41 BERKELEY STREET

SOUTH END LANDMARKS ADVISORY 3
APRIL 2022

41 BERKELEY STREET | SOUTH END LANDMARKS ADVISORY MEETING | 19 APRIL 2022

Preservation Challenges - Franklin Union Building

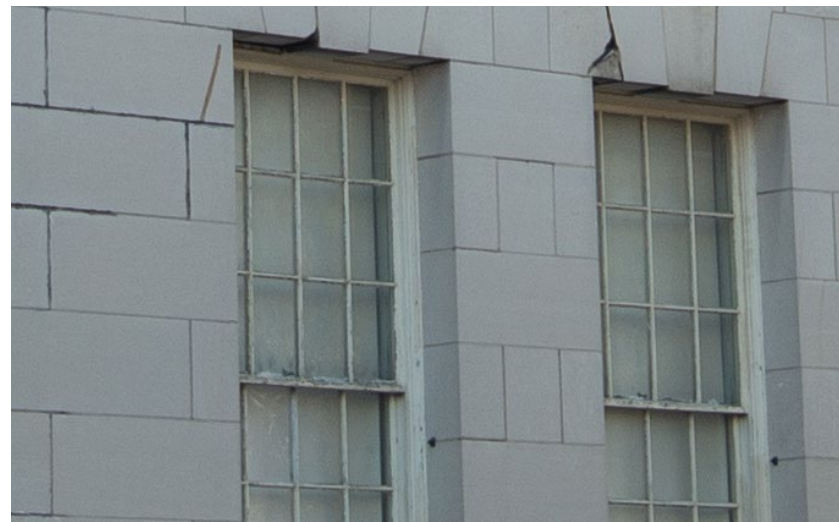
- Concrete pile caps supported by wood piles.
- Wood piles in average conditions with light soft rotting occurring, cracking at concrete pile caps.
- Supplemental piles and underpinning required to maintain existing loads.

- Load-bearing mass masonry supporting interior floors and roof and providing weather resistance.
- Deferred maintenance + deterioration requires full masonry repair, steel corrosion occurring on structural elements from failed weatherproofing.
- Repoint 100% of Brick Façade + 50% of Stone Masonry
- At all masonry repairs, assume the inner wythe will require rebuilding

- Wood framed with monolithic glazing and paint finish at window exteriors.
- Severely deteriorated, sills, jambs, sashes and perimeter blocking are checked, perimeter sealant joints fail. Replacement recommended.
- All windows are beyond their useful life, need full overhaul or replacement

- No life safety sprinkler system.
- Steam heating system, no HVAC or fresh air.

- Roof needs replacement
- Slab underside concrete repairs at roof
- Rebuild spalled brick at all interior basement walls

Preservation Challenges - 4 Appleton

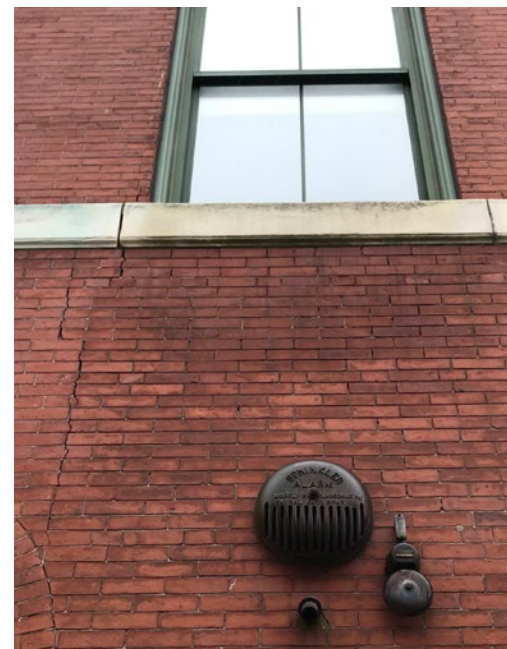
- Front facade window surrounds and arch expression remain, cornice is lost, left arch has been infilled with a concrete stair landing.
- Existing windows are metal replacements.
- Left side elevation is a blank party wall.
- Rear facade includes 1980's stair tower addition.

- Interior heavily modified, existing structure does not meet fire resistance standards required by new Type 1 high-rise building.

- Existing wood piles deteriorated, cracking visible on facade.
- Basement and foundations of new senior care building require excavation of most of building footprint.

4 Appleton Design Evaluation

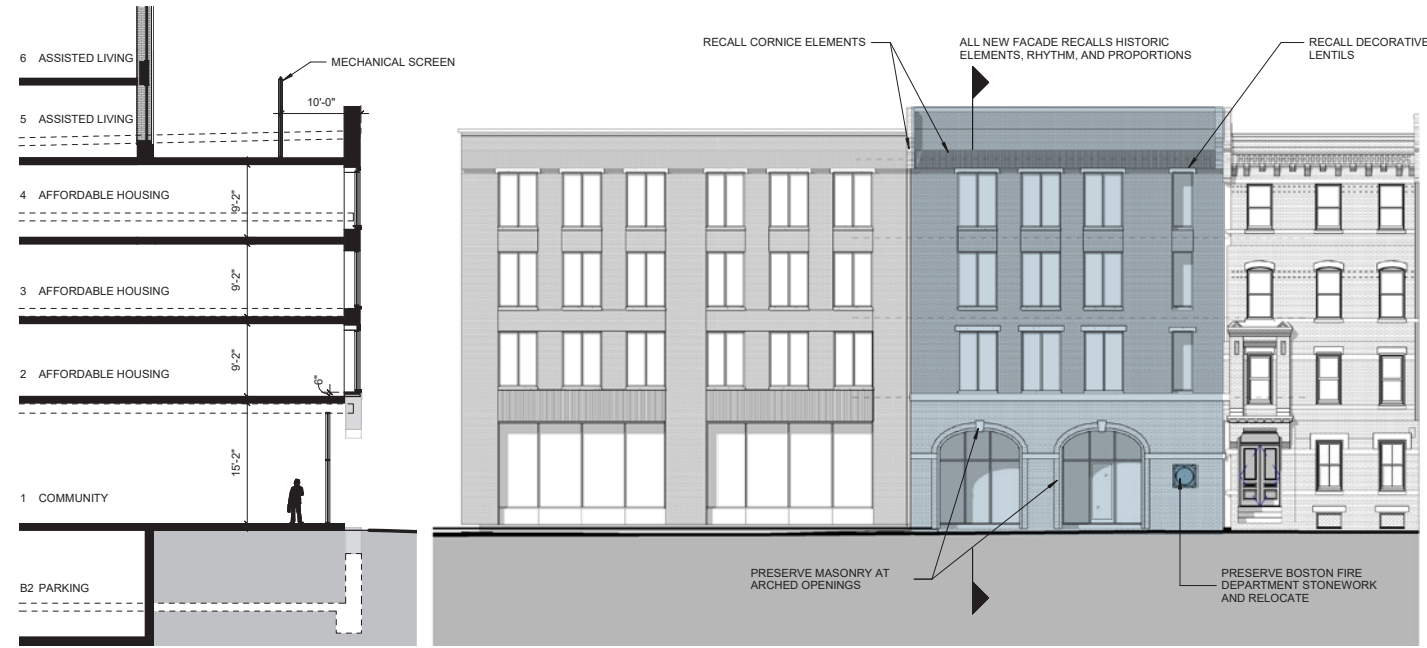
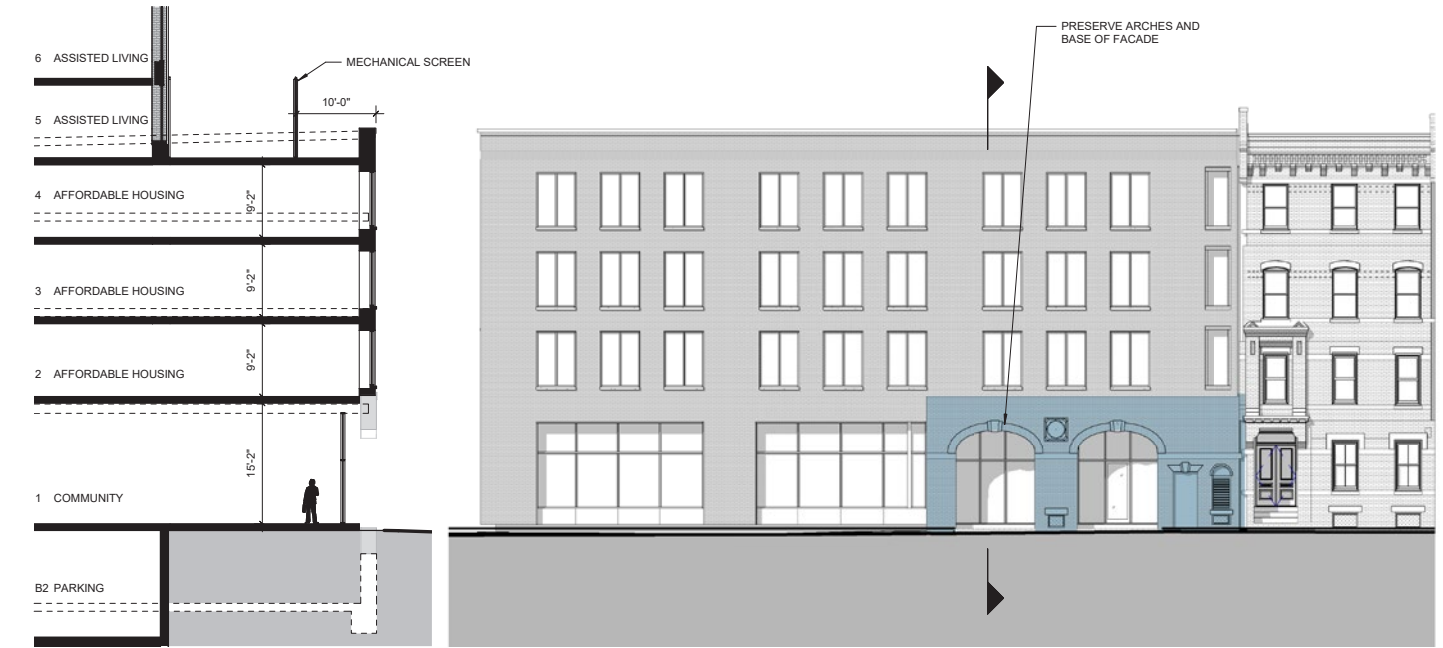
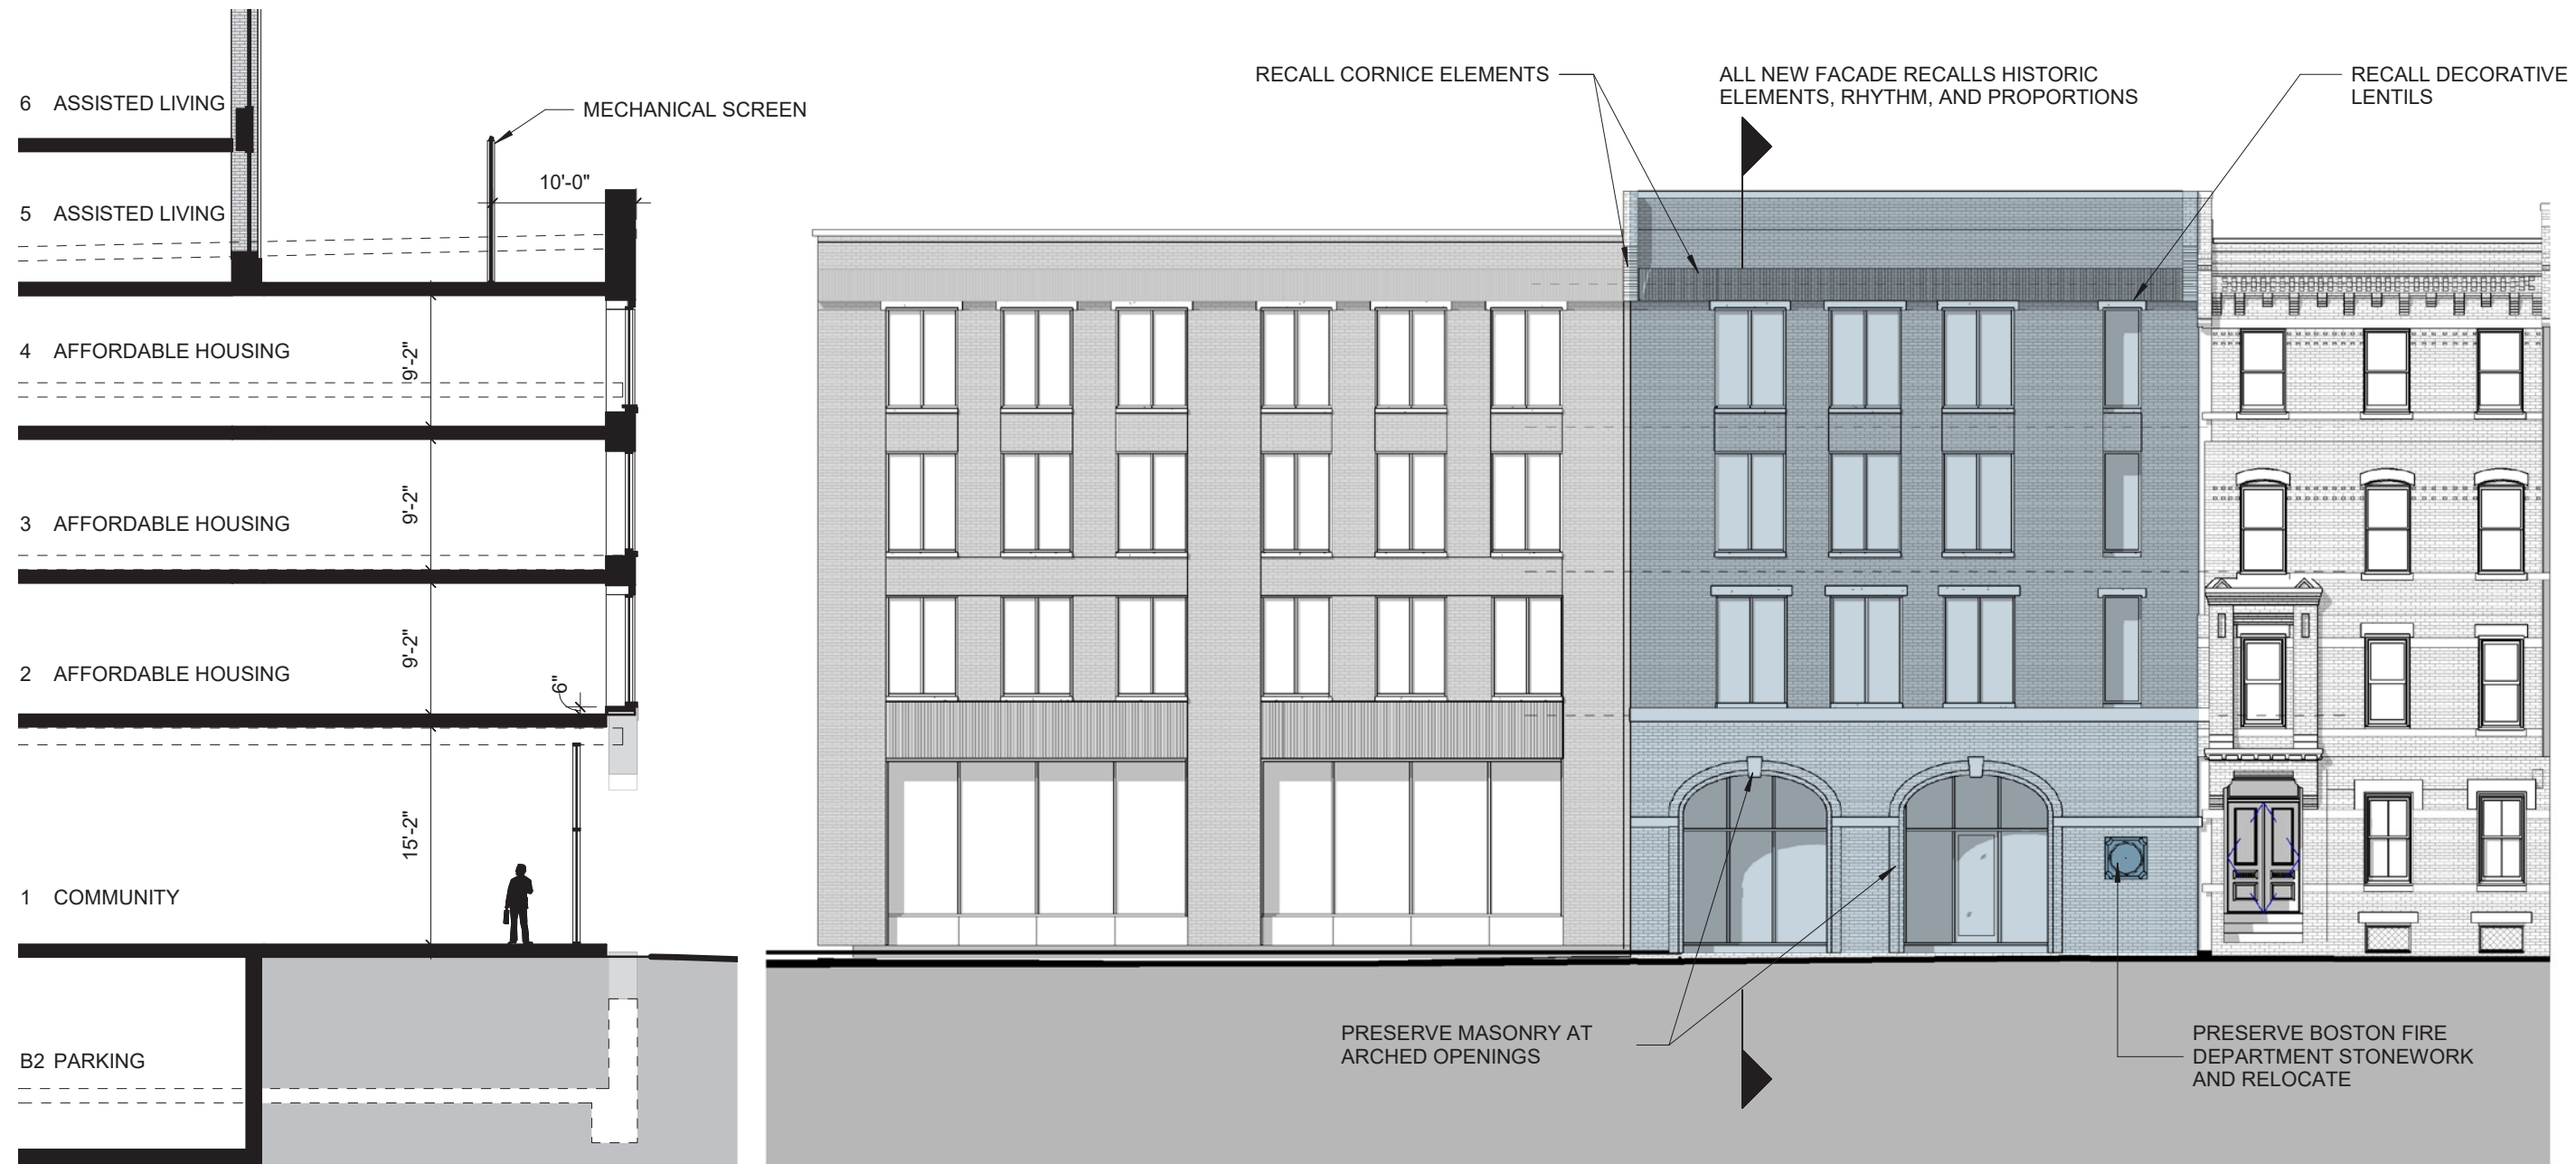
- Paired windows are not typical for the South End
- Language of existing arches should inform new elements
- Express cornices

Design Proposal - Construct New in the Spirit of the Old

Alternative Analysis 1: Preserve or Reconstruct Existing Arches

Alternative Analysis 2: All New Facade

Alternative Analysis 3: Preserve Historic Facade
